North Liberty Board of Adjustment
Information Packet

NORTH LIBERTY BOARD OF ADJUSTMENT
MEETING NOTICE AND AGENDA
June 15, 2016, 6:30 PM

To: North Liberty Planning Commission
From: Dean Wheatley, Planning Director
Subject: Site Plan and Outside Eating Approval Request
(Lot 24 Liberty's Gate Part 2)

6 C9.0 TYPICAL BERM CROSS SECTION
SCALE : NTS

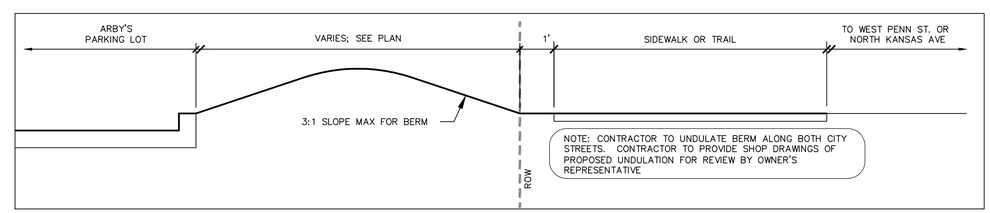
DRAWN BY: NHS			/ /
CHECKED BY: KWD			/ /
APPROVED BY: KWD	2	CITY COMMENT – ADD BERMING BEHIND KANSAS AVENUE SIDEWALK	5/24/16
DATE: 5/24/16	1	APPROVAL SUBMITTAL	5/19/16
FIELD BOOK: OT97	NO.		DATE

PATIO DETAIL

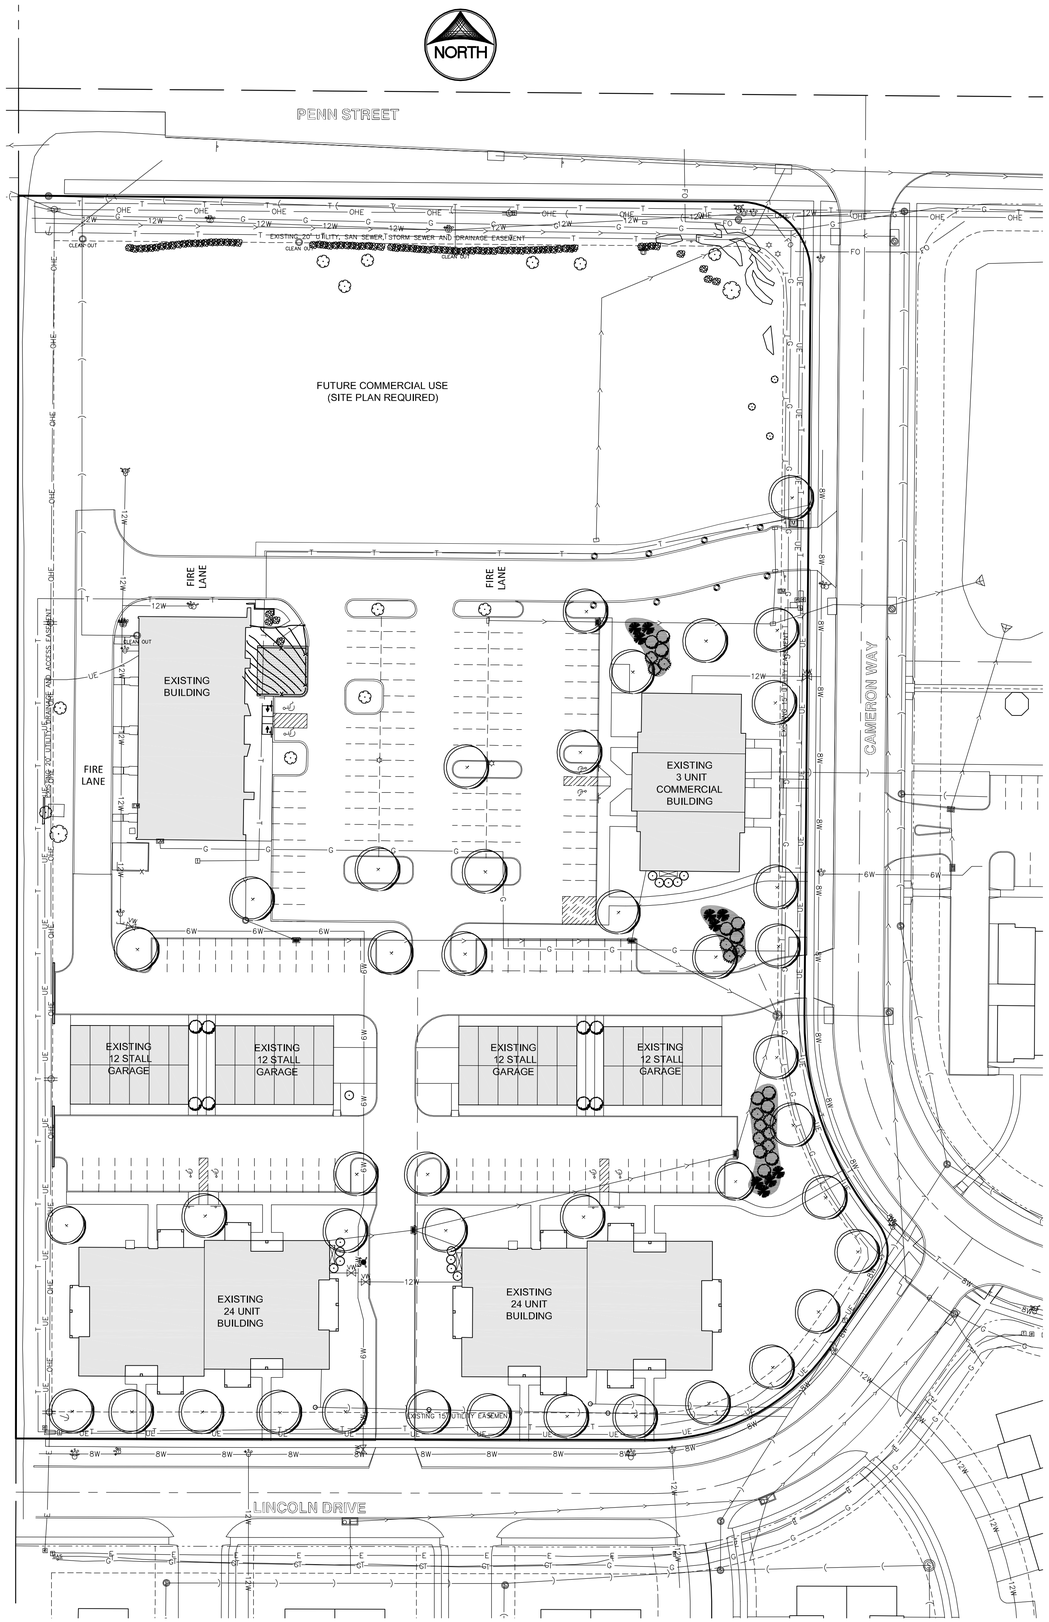
The specific plans for the patio are to use wrought iron fencing to establish an approximately 1,200 square foot area at the front of the restaurant with access to the restaurant through a roll-up overhead door. Exhibit photos intended to be replicated here include wrought iron fencing, large planting areas, and lighting, and pergola-type coverings. Food and alcohol will be served if approved.

Due to the very close residential uses, noise will be a major issue. This outside eating area should be developed as a quiet urban space and not a noisy venue.

1. Permit is for this owner only (future owners would need to reapply),
2. Alcoholic beverage sales allowed,
3. Only low-wattage lighting to be added – no floodlighting,
4. Amplified music levels to be agreed to in the field by the owner and City staff, and
5. No more seats than allowed by the Building and Fire Codes for this location.

1 FIRST FLOOR FINISH PLAN
1/8" = 1'-0"

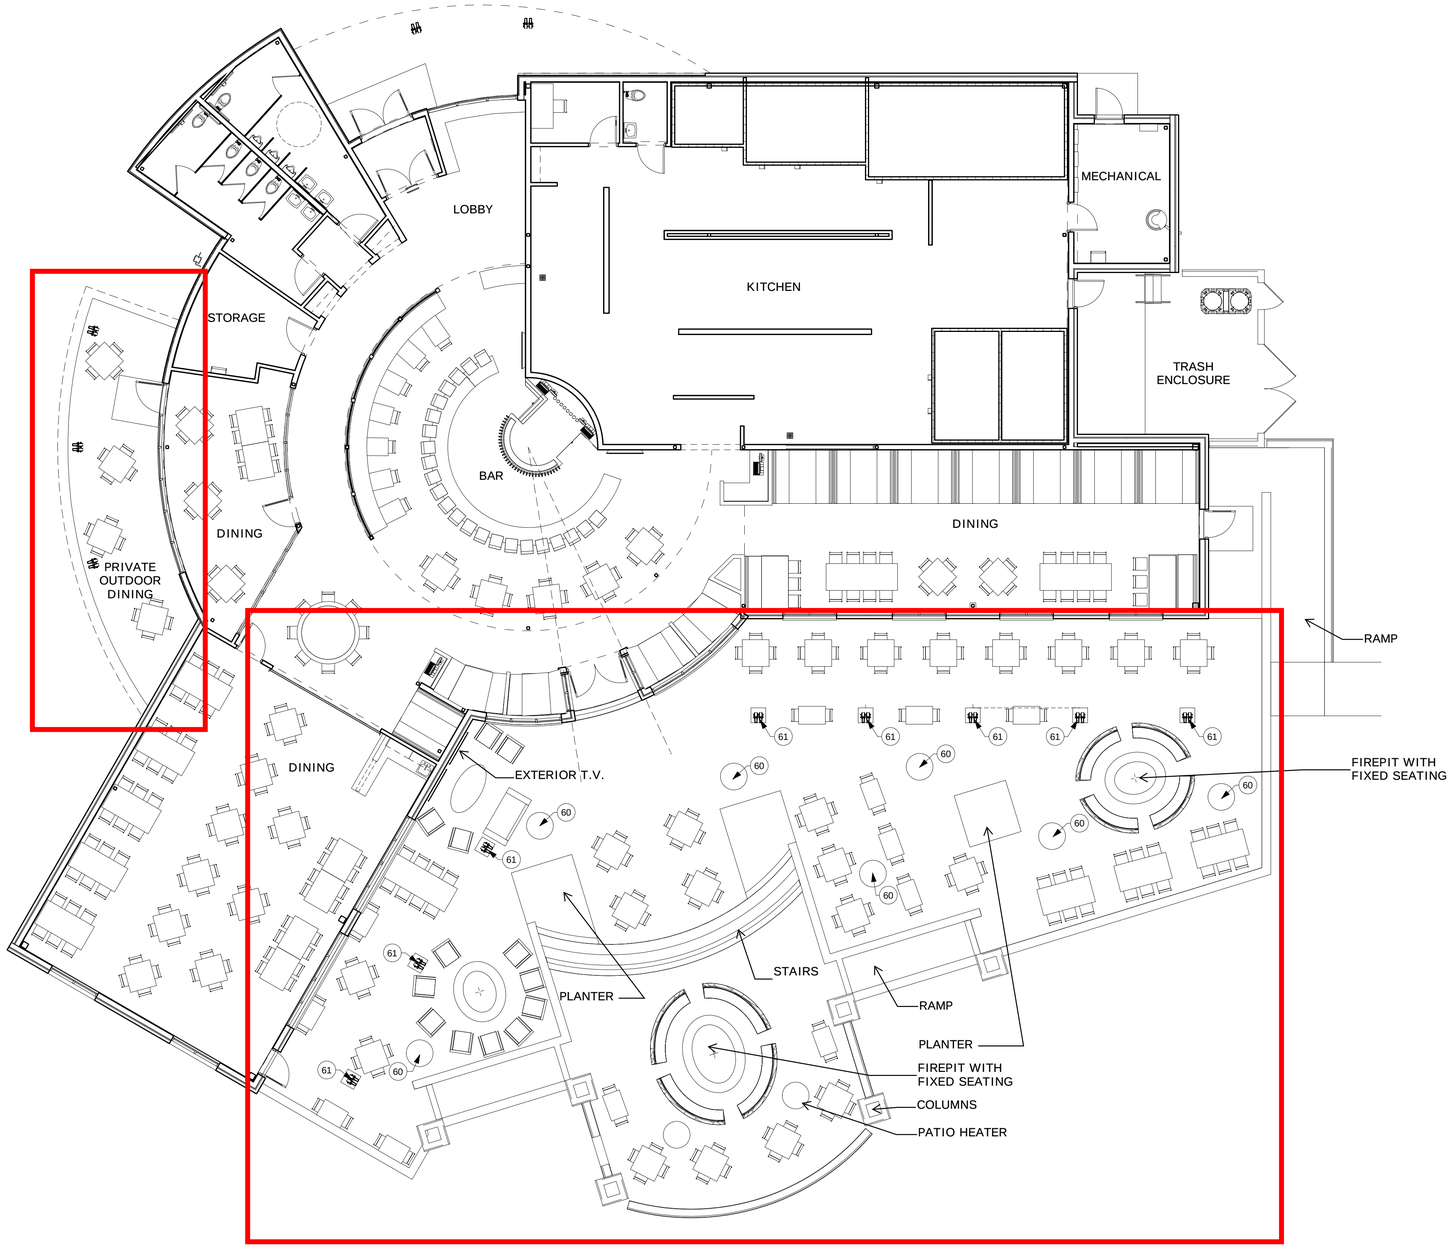
The specific plans for the patio are to use stonework and wrought iron fencing to establish a large, 197-seat area with outdoor lighting, alcohol service, and amplified music. Because of the building layout and situation on the lot, the outdoor patio is screened from Penn Street and mostly from Community Drive, with maximum exposure toward Liberty Centre Pond.

Although Liberty Centre is a commercial area and the pond was intended for just the sort of use proposed, the level of music amplification will need to be carefully modulated to avoid nuisance levels for nearby residential areas. This outside eating area should be developed as a commercial adult urban space and not a loud venue.

1. Permit is for this owner only (future owners would need to reapply),
2. Alcoholic beverage sales allowed,
3. Only low-wattage lighting to be added – no floodlighting,
4. Amplified music levels to be agreed to in the field by the owner and City staff, and
5. No more seats than allowed by the Building and Fire Codes for this location.
